ADDENDUM NO. [2]

Date: September 17, 2019

**RE: SCHOOL DISTRICT OF LA CROSSE
7 RIVERS CHARTER SCHOOL
225 5TH AVE SOUTH
LA CROSSE, WI 54601
HSR 19003**

2 FIRST FLOOR DEMOLITION PLAN
1/8" = 1'-0"

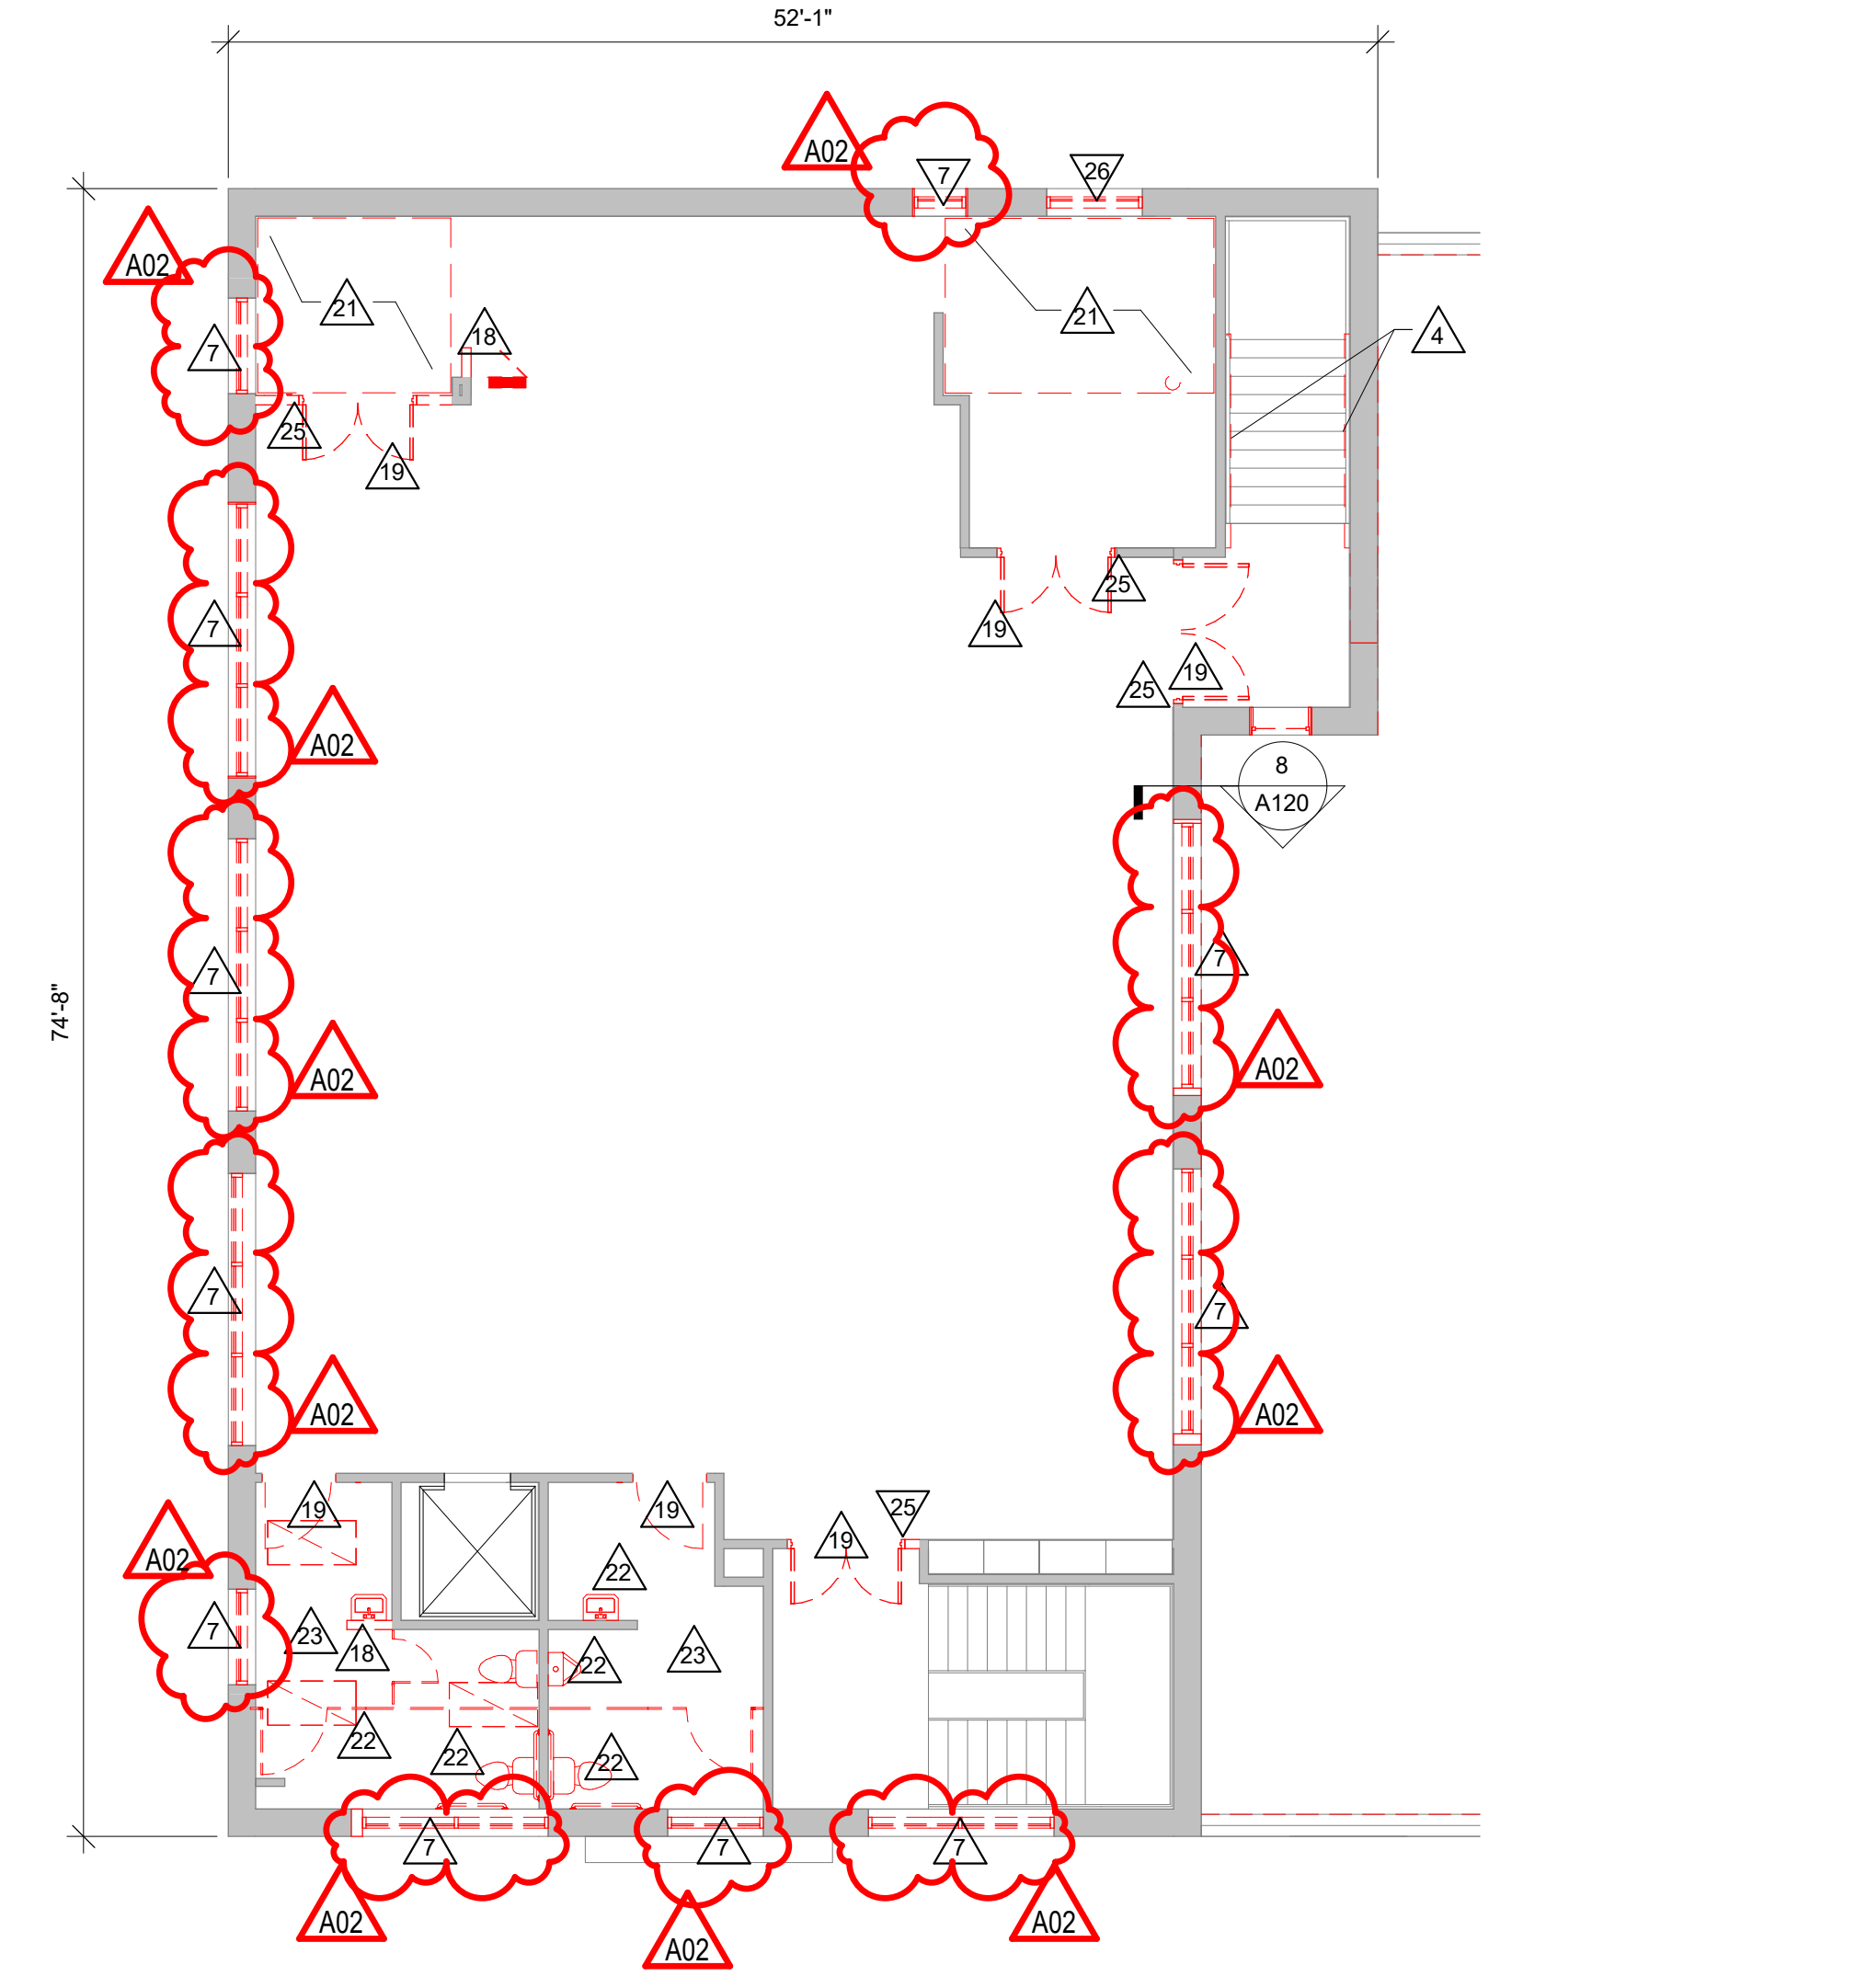
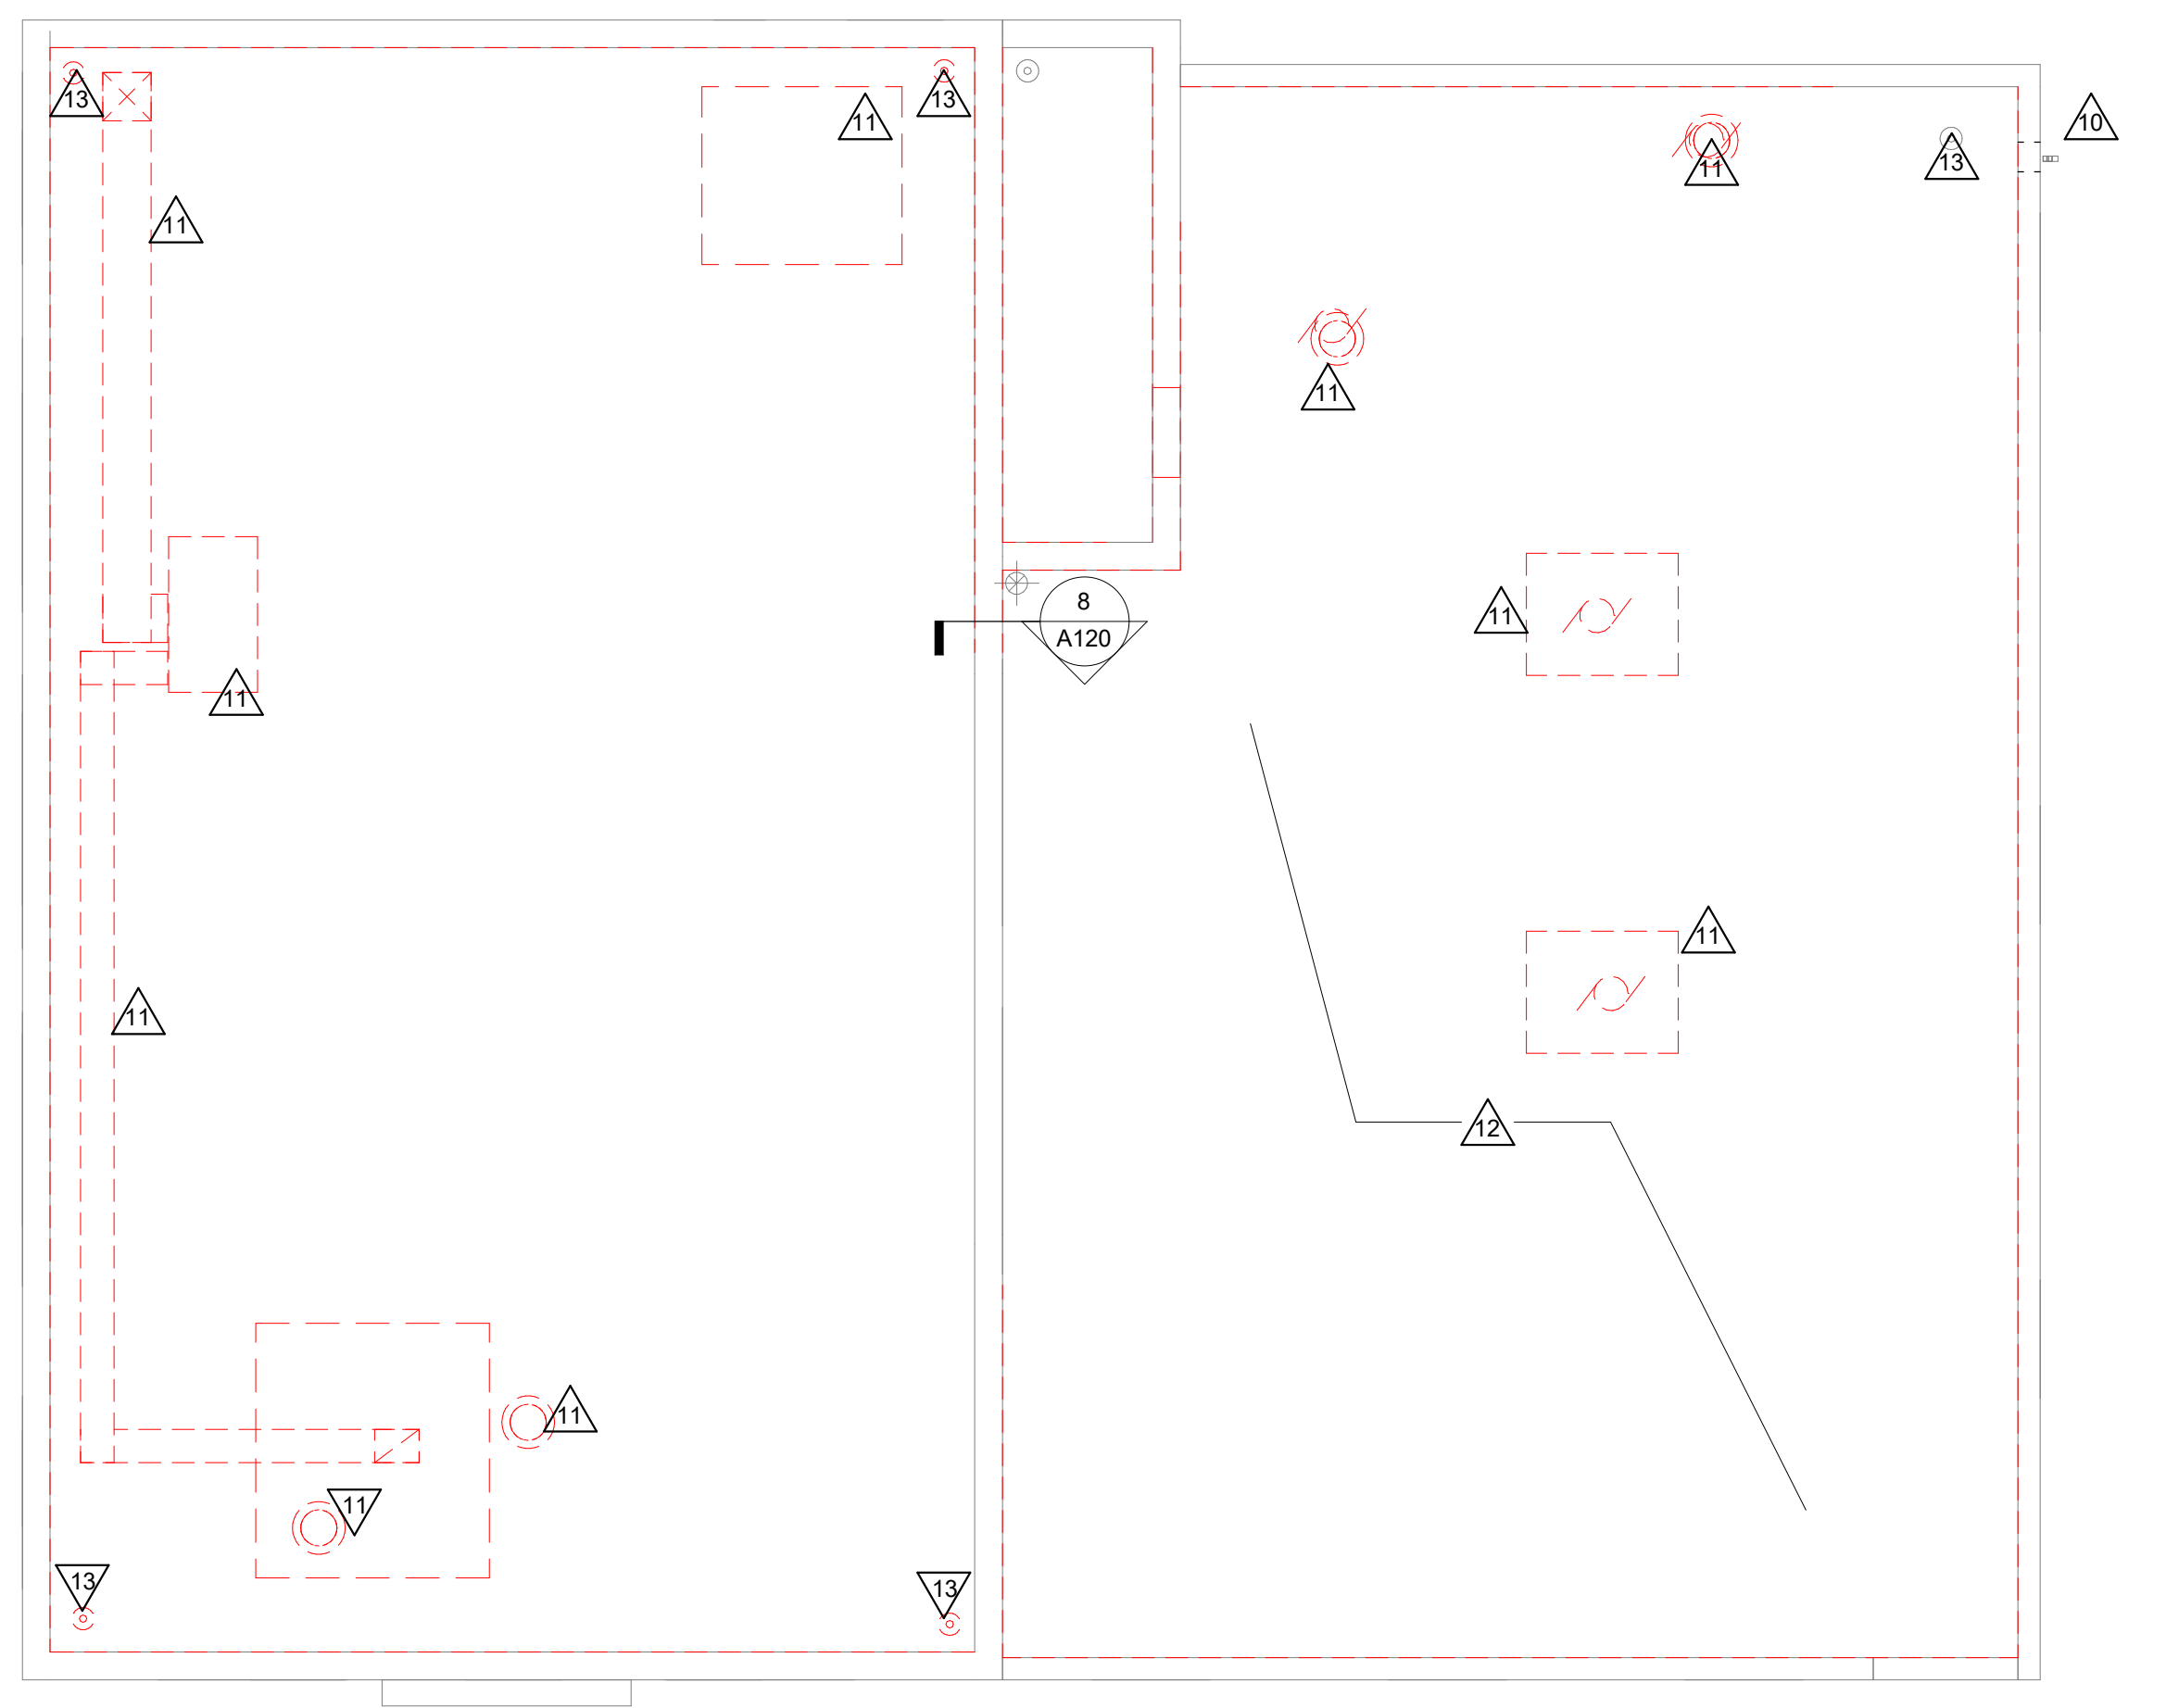
- a. Revisions clouded on Drawing.
- b. All existing windows shall be replaced.

11. Sheet A101 FIRST FLOOR REMODEL PLAN 30 x 42 attached hereto

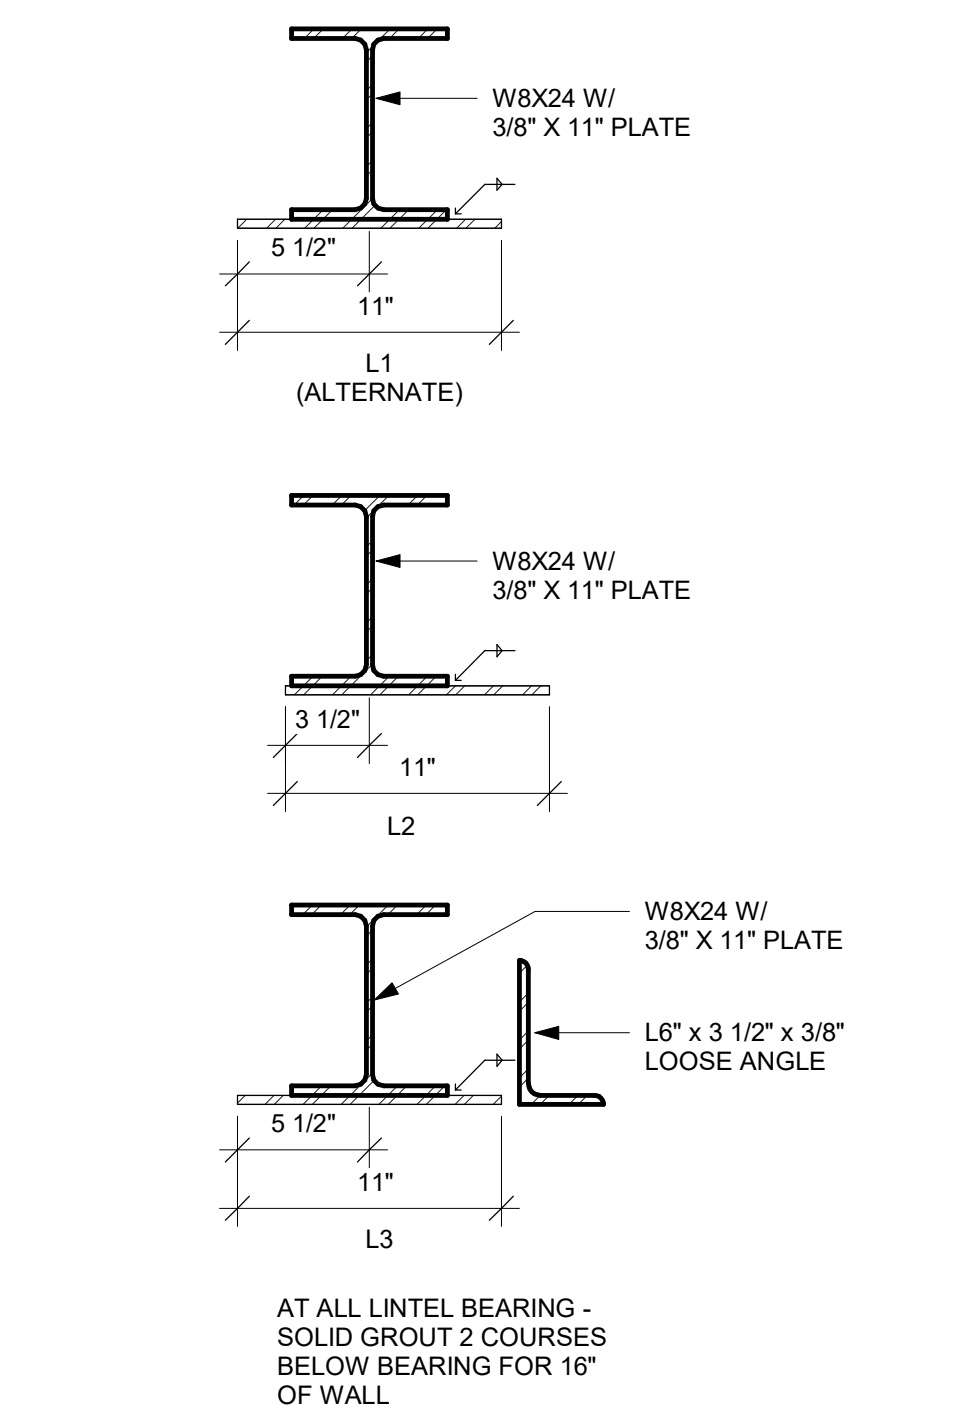
- a. Revisions clouded on Drawing.
- b. New windows shown.
- c. Revised keynotes 9.
- d. Delete Note 43. Fire shutters have been removed from project.
- e. Closet 109- removed references to keynote 10.
